## David Manteit V Brisbane City Council 2916/24

### Reference material and responses to Brisbane city Council Expert Witness reports

### Corrigan report.

The appellant's calculations of usable building pad levels and lawful point of discharge are as follows -

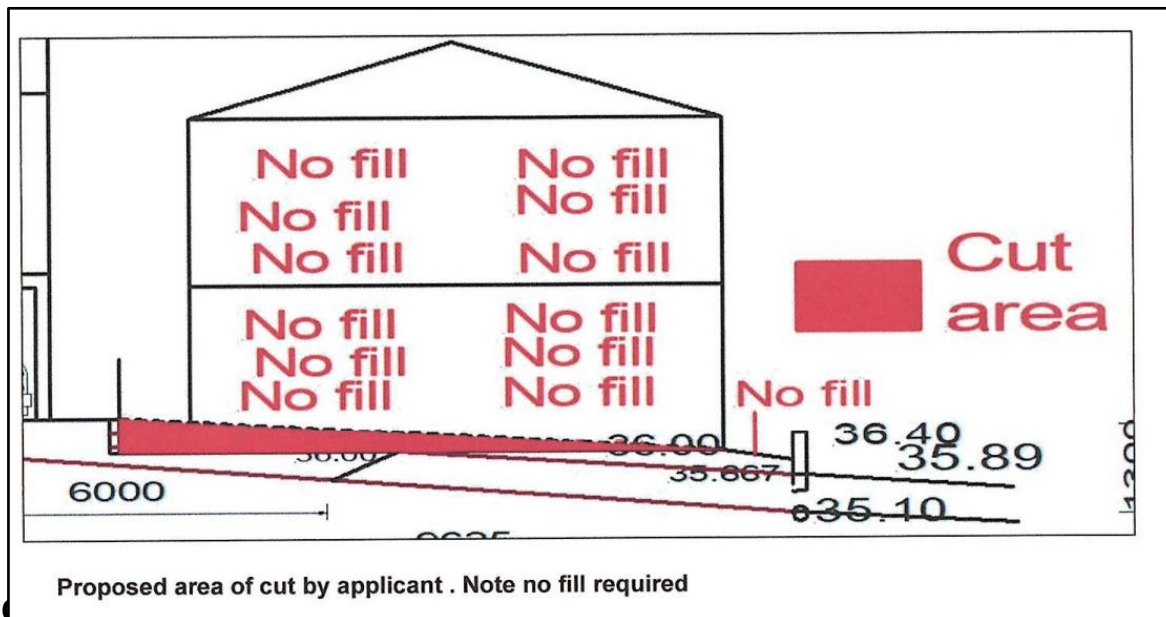
Lawful point of discharge at kerb, 500mm from boundary	35.100	
Fall over verge 1:100 as per BSD 8111	.038	
Min IL at front boundary	35.138	
Pipe diameter as per BSD 8111	.150	
Minimum Cover as per BSD 8111	.450	
Min FSL required at front boundary		35.738
ESL at front boundary as per surveyor	35.859

Fall pipe 150mm 1:100 over 6 metres from boundary,	.060	
Minimum FSL at 6 metre setback= start of usable pad		35.798

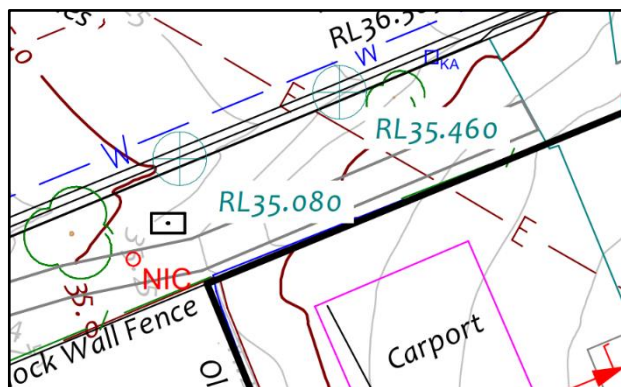
79. The result is that the RPEQ Corrigan certified Upstream hydraulic system is charged by 363 mm to the kerb 35.053

80. RPEQ Corrigan wants to send water uphill from pit This is a charged pipe that is called a flood.

Corrigan proposes to flood the site, in the same way as the Council employee illegal red line with no RPEQ certification. Who would have thought another flooded pipe would be seen.

81. RPEQ Corrigan wants to raise the land at pit 6 by 385 mm.

**83 Corrigan plan to cause the demolition of the existing house.**

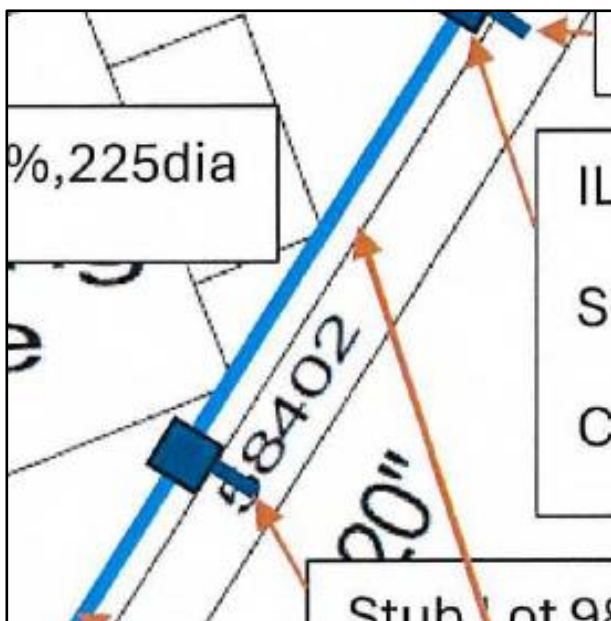
84. Pipe between Lot 97 and Lot 98 will travel within 700mm of back fire escape steps. Hence part of the house would need to be demolished.

85. In addition, It is not possible to place a concrete pit 600mm to centre, and have sufficient drainage gravel.

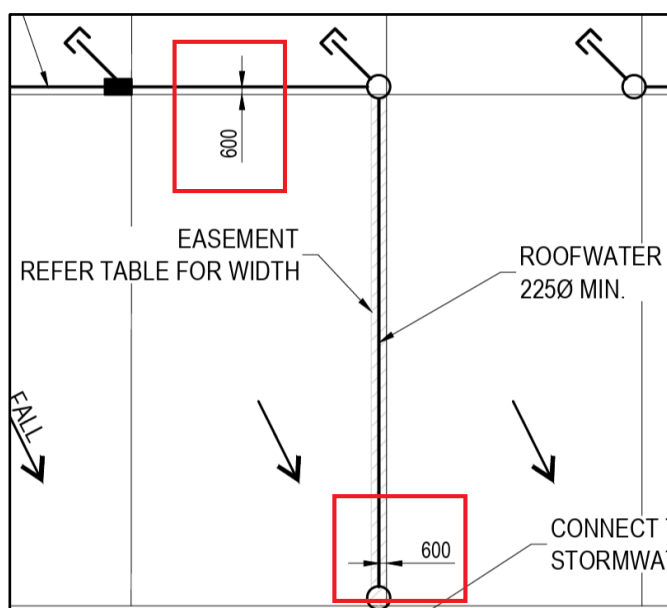
92. BSD 8111 requires that the stormwater pipe is to be 600mm away from the boundary.

93. It has been upheld by the Planning Court, 4139/18 a Council red pen shown an upstream pipe did not show a pipe outside 600mm from the boundary.

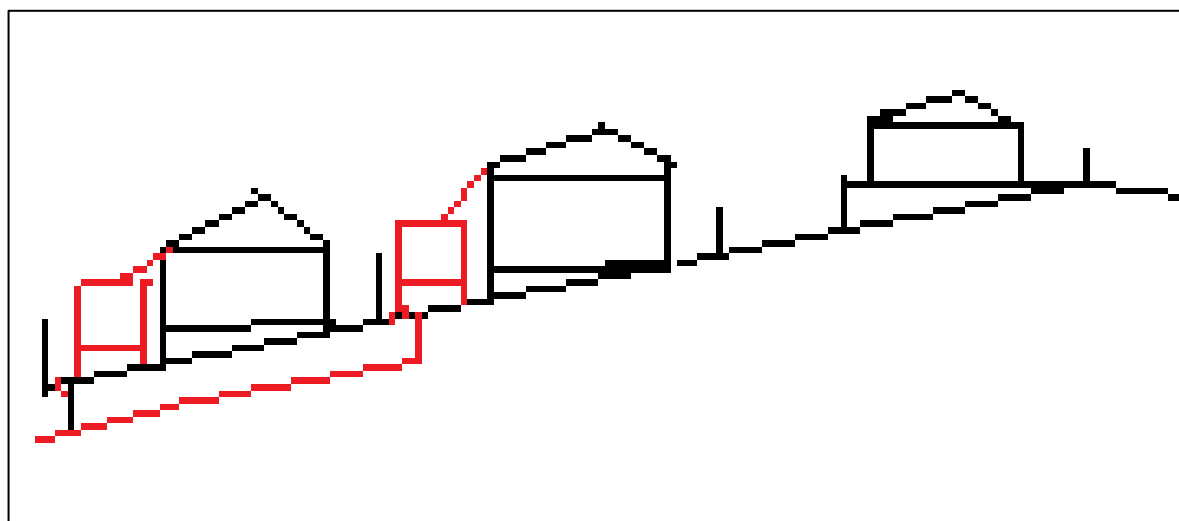
It is unsure how Corrigan can get 71.3 litres per second into 2 kerb adaptors of 30 litres capacity.

**Corrigan has water tanks for 75 - 28 litres per second = 47 litres per second = 169,200 litres per hour, as per fraction impervious. This is 17 \* 10,000 litre water tanks required. That's 6 water tanks required per property. 5 square metres per tank = 30 square metres gone in your backyard.**

**117. Corrigan** has not done a reconciliation of his numbers
